PRODUCT / PROCESS CHANGE NOTIFICATION

1.1 Company	 STMicroelectronics International N.V
1.2 PCN No.	ADG/22/13856
1.3 Title of PCN	DPAK Big Die Dual Die line Transfer from Shenzhen to Tongfu Microelectronics (China)
1.4 Product Category	Power MOSFET HV – IGBT – Power Bipolar
1.5 Issue date	2022-12-22

Comparison DPAK Shenzhen vs TFME

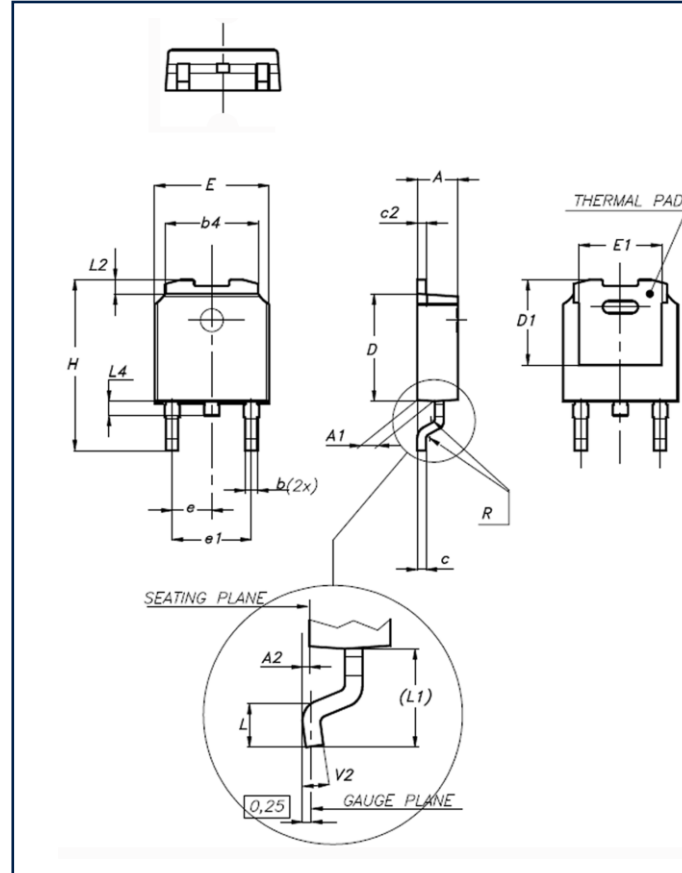
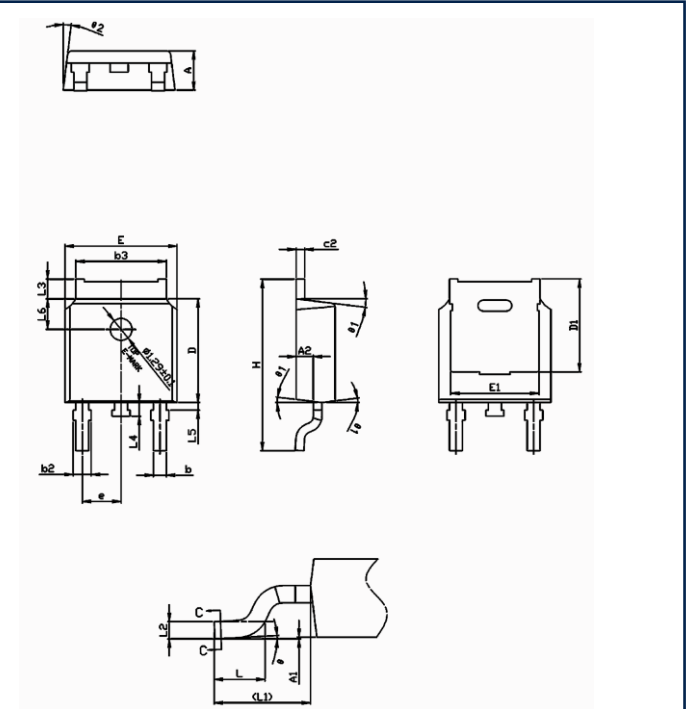
Dim.	mm			Dim.	mm		
	Min.	Typ.	Max.		Min.	Typ.	Max.
A	2.20		2.40	A	2.20	2.30	2.38
A1	0.90		1.10	A1	0.00		0.10
A2	0.03		0.23	A2	0.90	1.01	1.10
b	0.64		0.90	b	0.72		0.85
				b2	0.72		1.10
				b3	5.13	5.33	5.46
b4	5.20		5.40				
c	0.45		0.60	c	0.47		0.60
c2	0.48		0.60	c2	0.47		0.60
D	6.00		6.20	D	6.00	6.10	6.20
D1	4.95	5.10	5.25	D1	5.15	5.40	5.65
E	6.40		6.60	E	6.50	6.60	6.70
E1	5.10	5.20	5.30	E1	5.00	5.20	5.40
e	2.159	2.286	2.413	e	2.186	2.286	2.386
e1	4.445	4.572	4.699				
H	9.35		10.10	H	9.80	10.10	10.40
L	1.00		1.50	L	1.40	1.50	1.70
(L1)	2.60	2.80	3.00	L1	2.90 REF		
L2	0.65	0.80	0.95	L2	0.51 BSC		
				L3	0.90		1.25
L4	0.60		1.00	L4	0.60	0.80	1.00
				L5	0.15		0.75
				L6	1.80 REF		
				Θ	0°		8°
R		0.2		Θ 1	5°	7°	9°
V2	0°		8°	Θ 2	5°	7°	9°
